RE: CARGILL FERTILIZER, INC. MAP PLANT EXPANSION - RIVERVIEW DEP FILE
NO. 0570008-026-AC (PSD-FL-251)

TO: John Reynolds, FDEP Tallahassee
FROM: *HS* Heidi Swanson, EPC Air Management
THROUGH: *RK* Richard C. Kirby IV, P.E.
DATE: July 7, 1998
SUBJECT: FDEP File No. 0570008-026-AC (PSD FL-251)
 Cargill Fertilizer, Inc., MAP Plant Expansion

**Technical Review of Prevention of Significant Deterioration Permit Application
For the Expansion of the Monoammonium Phosphate (MAP) Plant
Cargill Fertilizer Plant
Riverview, Florida
PSD-FL-251**

Re: Cargill Fertilizer, Inc.
Permit No. AO29-239263
Modification of Raymond Mills No. 5 and 9, Riverview
DEP File No. 0570008-008-AC

Figure 1. All PM Emissions Tests

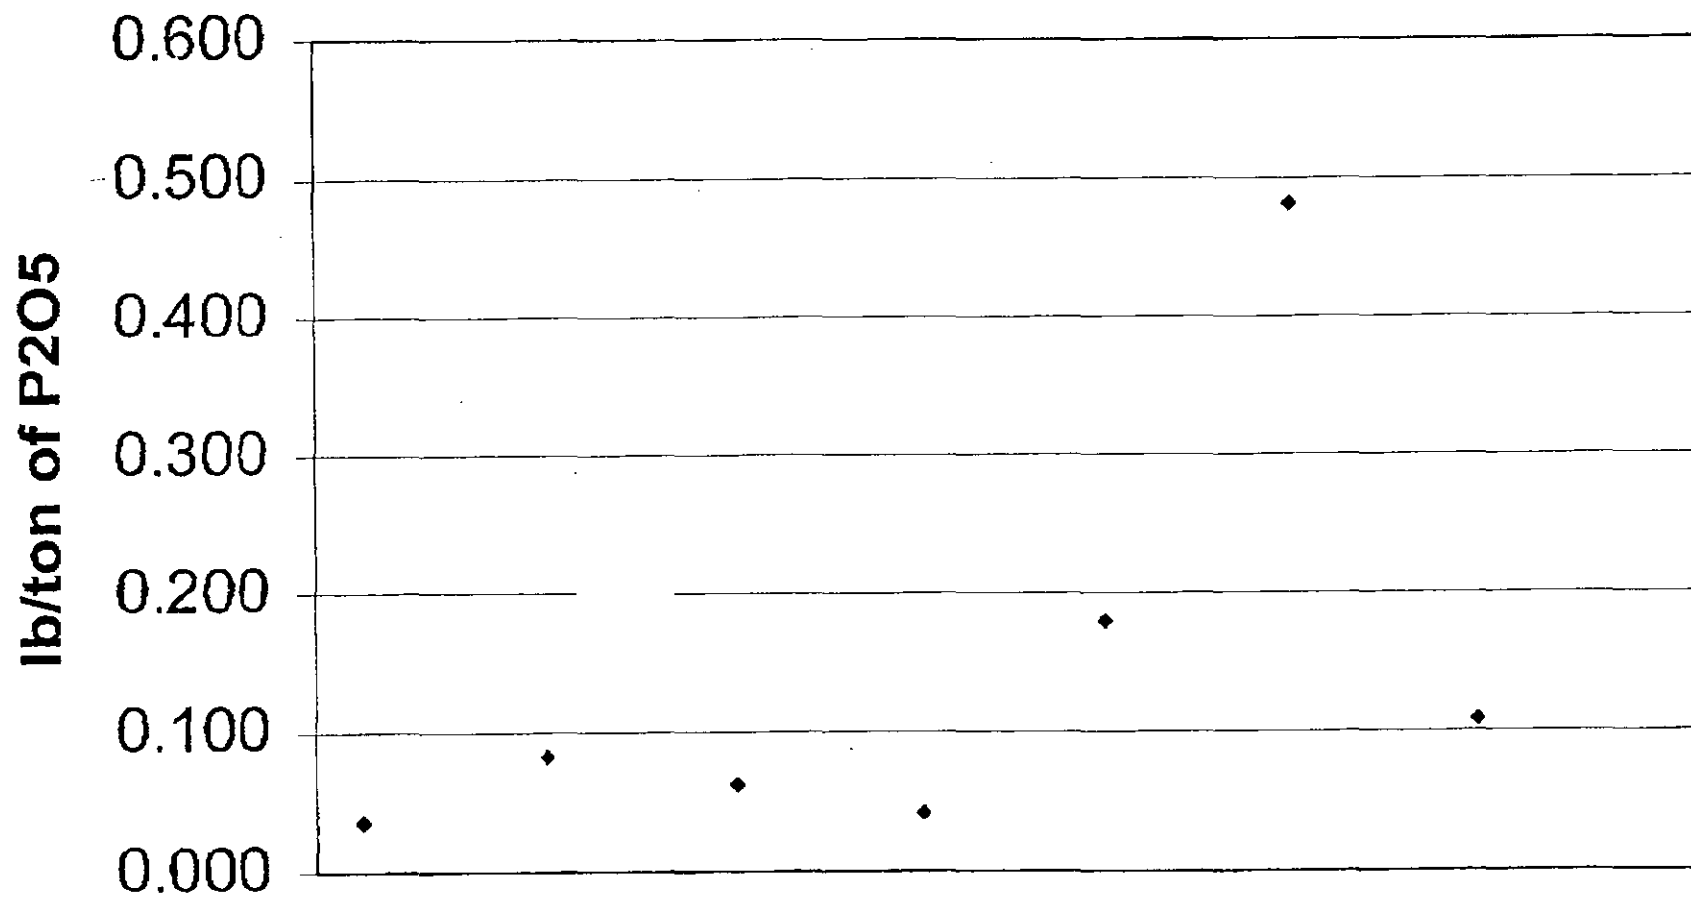
A closer inspection of the stack test data in Figure 1 indicates that Cargill has included results from 4/1/93 tests that are extraordinarily high and should have been deleted as "outliers." A comparison of the median and average PM stack test values in Table 1 shows that the average test value is almost double the median. Therefore, it is likely that an exceptionally high value is unduly biasing the results.

Figure 2. PM Emission without 4/1/93

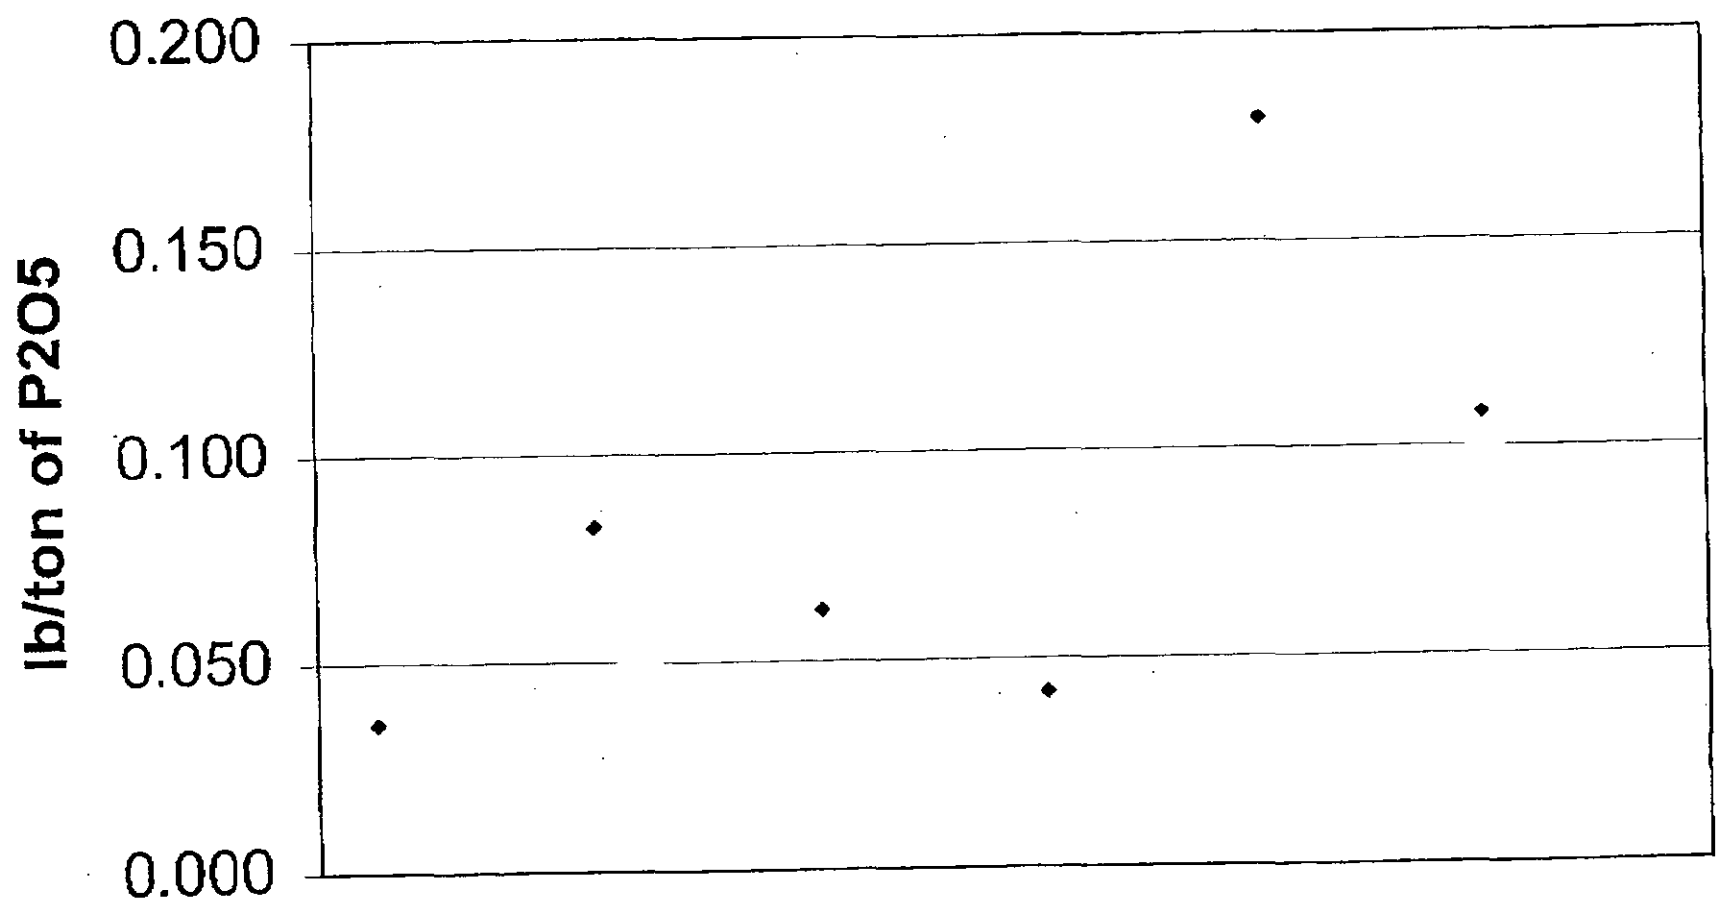
If the outlier results of the 4/1/93 test are eliminated, Table 2 and Figure 2 are the result. Not only is the scatter plot more regular, but the average and median PM values converge nicely, indicating that there are no unusual biases. The resulting 95% confidence intervals predict that, if the plant is operating properly, it should be able to meet limits of 0.13 lb PM/ton phosphate and 0.019 lb F/ton phosphate 95% of the time. Even if Cargill's emission limits are based upon

the expected performance of the existing control equipment, those limits should be a function of the phosphate input rate and should be not more than 0.13 lb PM/ton phosphate and 0.019 lb F/ton phosphate.

Figure 1. All PM Emissions Tests

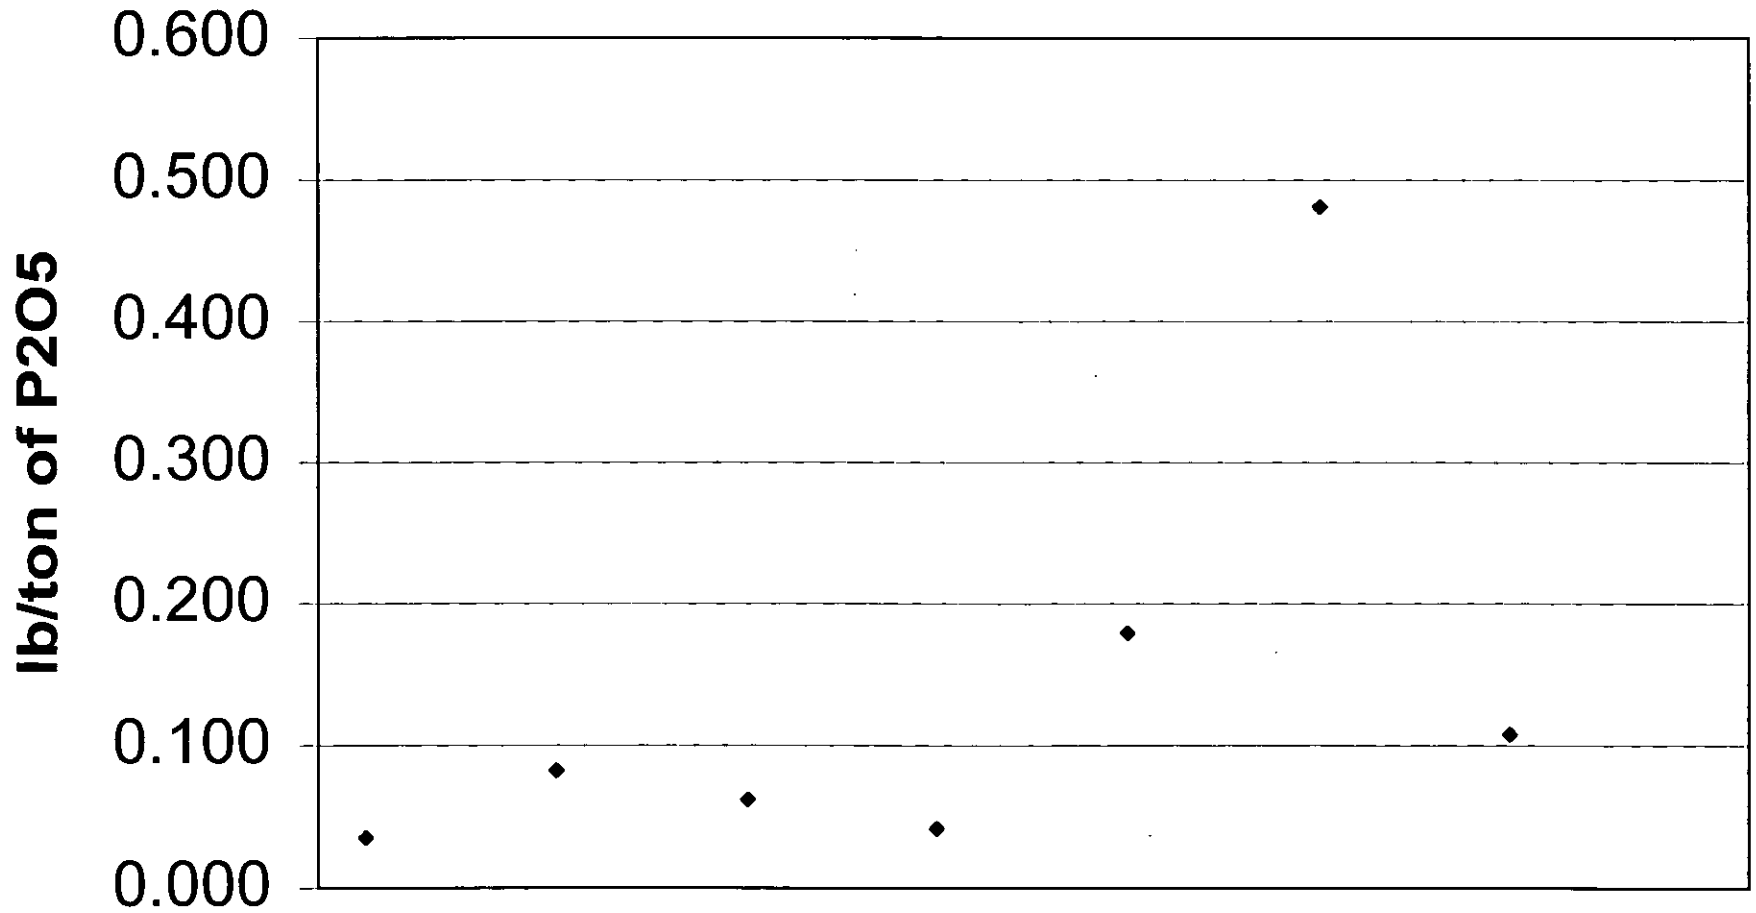
A closer inspection of the stack test data in Figure 1 indicates that Cargill has included results from 4/1/93 tests that are extraordinarily high and should have been deleted as "outliers." A comparison of the median and average PM stack test values in Table 1 shows that the average test value is almost double the median. Therefore, it is likely that an exceptionally high value is unduly biasing the results.

Figure 2. PM Emission without 4/1/93

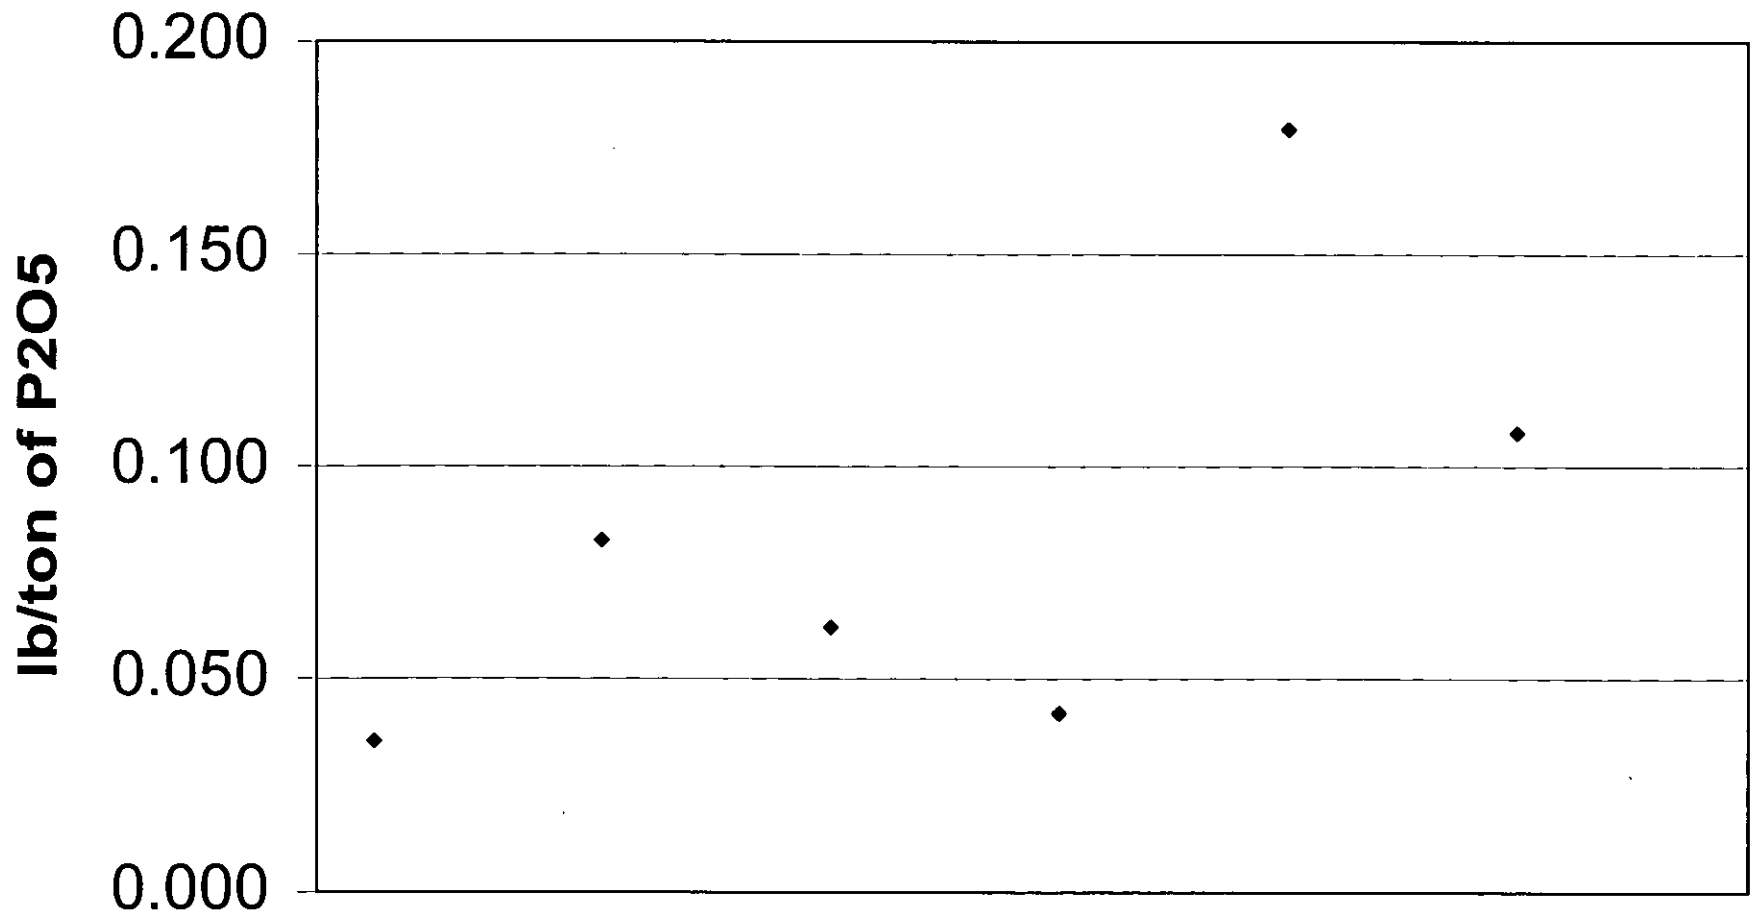
If the outlier results of the 4/1/93 test are eliminated, Table 2 and Figure 2 are the result. Not only is the scatter plot more regular, but the average and median PM values converge nicely, indicating that there are no unusual biases. The resulting 95% confidence intervals predict that, if the plant is operating properly, it should be able to meet limits of 0.13 lb PM/ton phosphate and 0.019 lb F/ton phosphate 95% of the time. Even if Cargill's emission limits are based upon the expected performance of the existing control equipment, those limits should be a function of the phosphate input rate and should be not more than 0.13 lb PM/ton phosphate and 0.019 lb F/ton phosphate.

Figure 2-1
Process Flow Diagram of Existing System

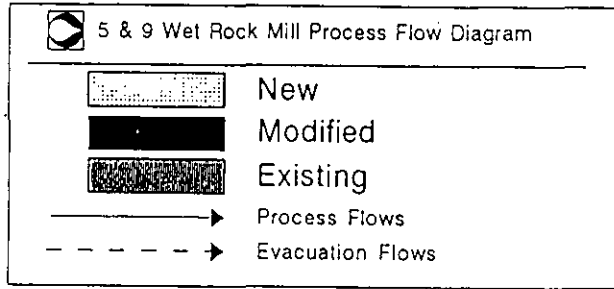
5. As we discussed during our meeting on February 5, 1996 at your facility, submit a revised Attachment A, which includes Figure 2-1 and Figure 2-2, that **accurately** describes the existing operation and the proposed modified operation. Be sure the submittal describes/shows all air flows, all raw material/fuel flows, all dry rock flows, clearly explains/shows the existing vs. new vs. upgraded equipment, consistently uses the same terms/names, and explains what equipment operates simultaneously and/or can operate independently (e.g., wet/dry receiving elevator can operate independently of the dryers/grinders - Mills). Be sure the associated maximum operating rates are also included for each possible operating scenario.

11. The flow diagram of the existing system has been corrected to show the ground rock can discharge to either the ground rock bin or the surge bin.
12. At the maximum process rate, the proposed emission limit for the rock grinders/dryers is equivalent to 0.09 lb/ton of wet rock feed (5.18 lb/hr / 58.2 TH). These emissions were based on the manufacturer's guarantee of the baghouse performance. At these emission levels, each mill would be able to operate at rates as low as 10 TPH and still meet the 0.26 lb/ton combined limit (2.59 lb/hr / 10 TPH = 0.26 lb/ton). However, at lower process rates, it is reasonable to expect that the dust loading to the baghouse will decrease proportionately with the decrease in production
